SUNDRY NOTICES AND REPORTS ON WELLS (DO NOT USE THIS FORM FOR PROPOSALS TO DRILL OR TO DEEPEN OR PLUG BACK TO A DIFFERENT RESERVOIR. USE "APPLICATION FOR PERMIT" (FORM C-101) FOR SUCH PROPOSALS.)		WELL API NO. 30-015-53723
1. Type of Well: Oil Well ☐ Gas Well ☒ Other ☐		5. Indicate Type of Lease STATE ☐ FEE ☐
2. Name of Operator Mewbourne Oil Company		6. State Oil & Gas Lease No.
3. Address of Operator P.O. Box 5270 Hobbs, NM 88241		7. Lease Name or Unit Agreement Name Full Tilt 18/7 Fed
4. Well Location Unit Letter O : 320 feet from the South line and 1390 feet from the East line Section 18 Township 26S Range 30E NMPM County Eddy		8. Well Number 575H
11. Elevation (Show whether DR, RKB, RT, GR, etc.) 3110' GL		9. OGRID Number 14744
10. Pool name or Wildcat Purple Sage; Wolfcamp Gas

Mewbourne Oil Company requests to make the following changes to the APD:

WELL LOCATION AND ACREAGE DEDICATION PLAT

Full Tilt 18/7 Fed #575H

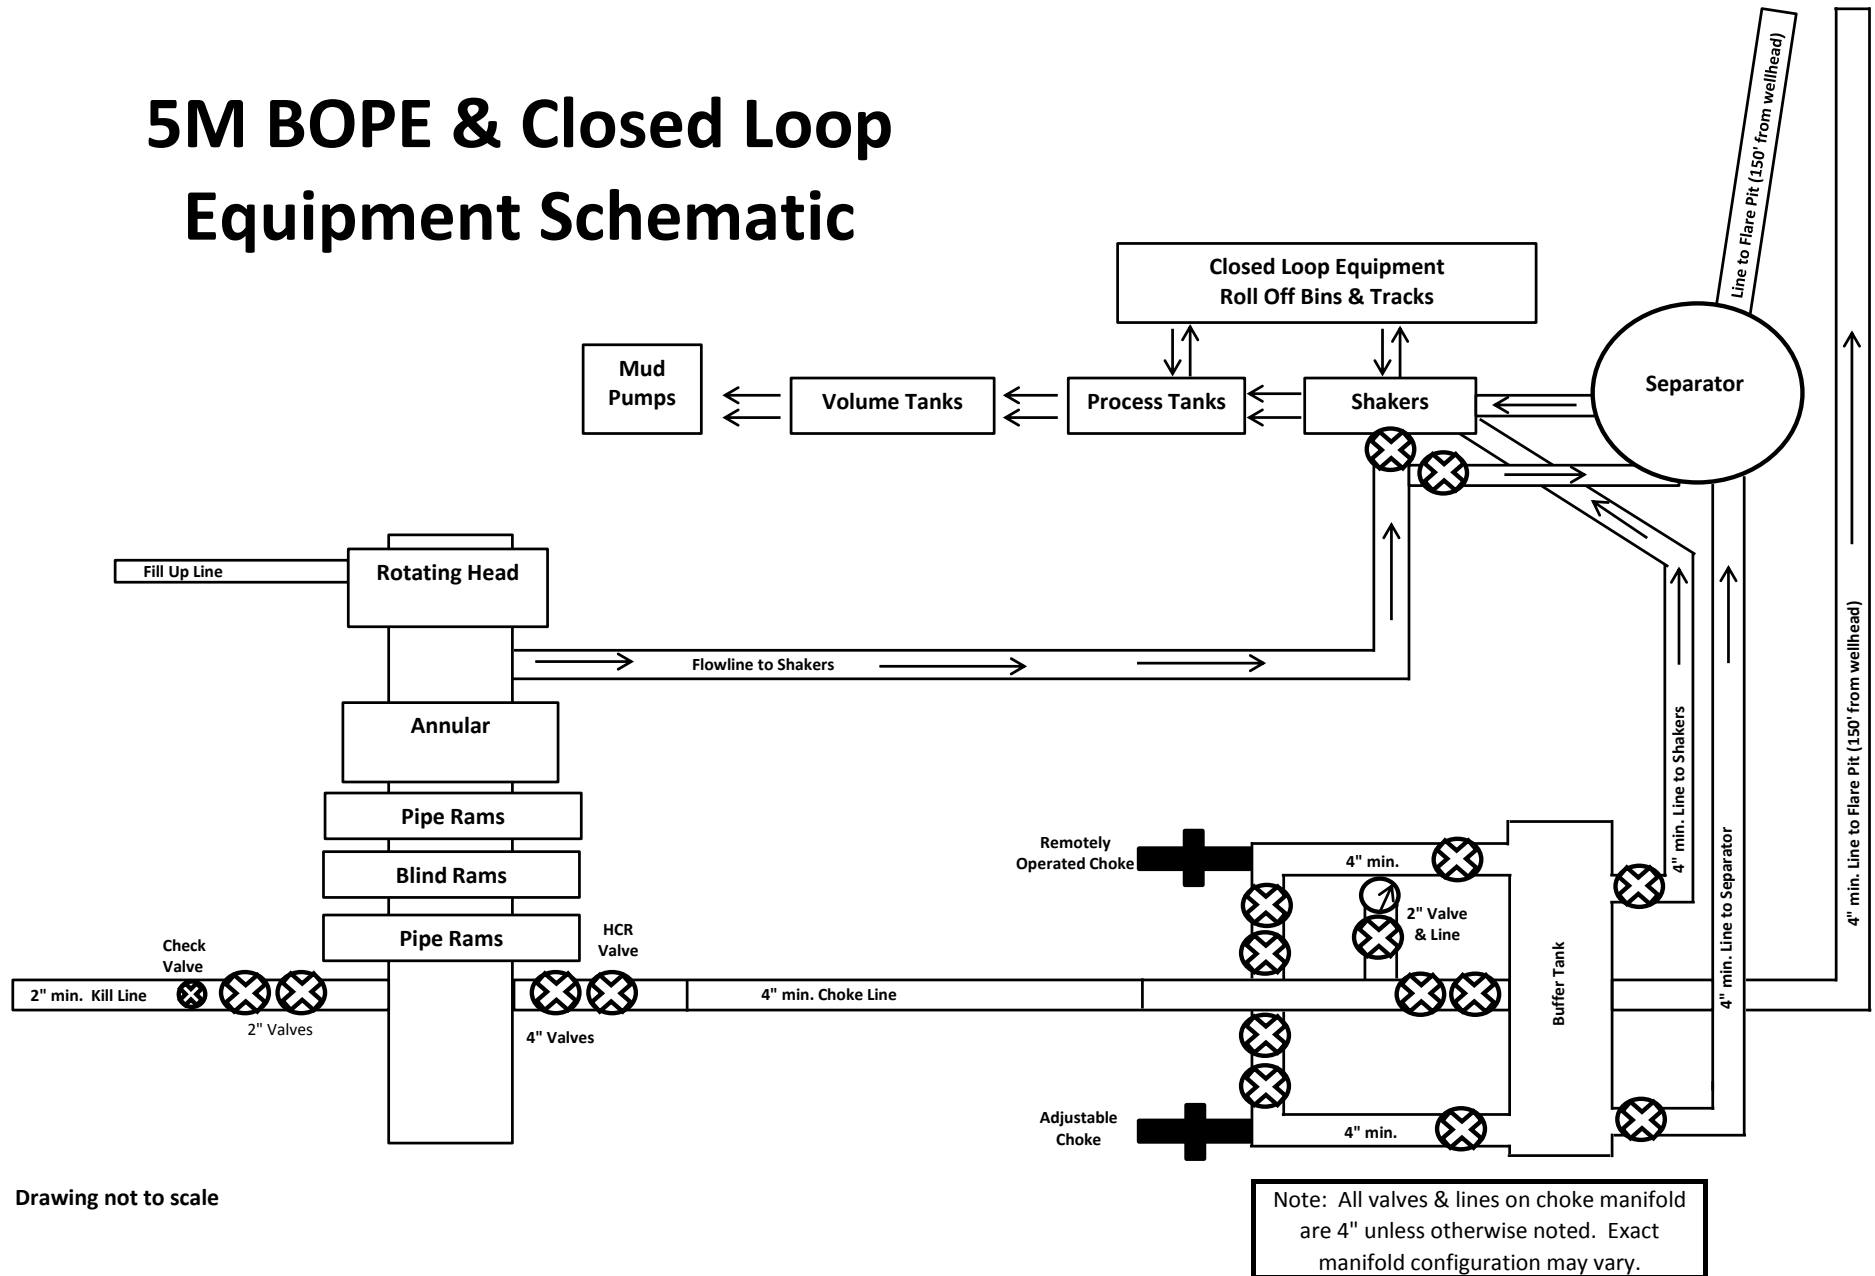
- Change SHL from 320' FSL & 1390' FEL (Sec 18, T26S, R30E) to 450' FSL & 1511' FEL (Sec 18, T26S, R30E). Please see attached updated C102
- Change BHL from 2430' FSL & 1310' FEL (Sec 7, T26S, R30E) to 2561' FSL & 2220' FEL (Sec 7, T26S, R30E). Please see attached updated C102
- Change pool from Purple Sage; Wolfcamp (Gas) to Corral Canyon; Bone Spring, South
- Change BOP/BOPE from 10M rating to 5M rating
- Change Casing/Cement/Mud program
- Please see attached drilling plan and other documentation referencing design changes and data that corresponds to said procedural alterations
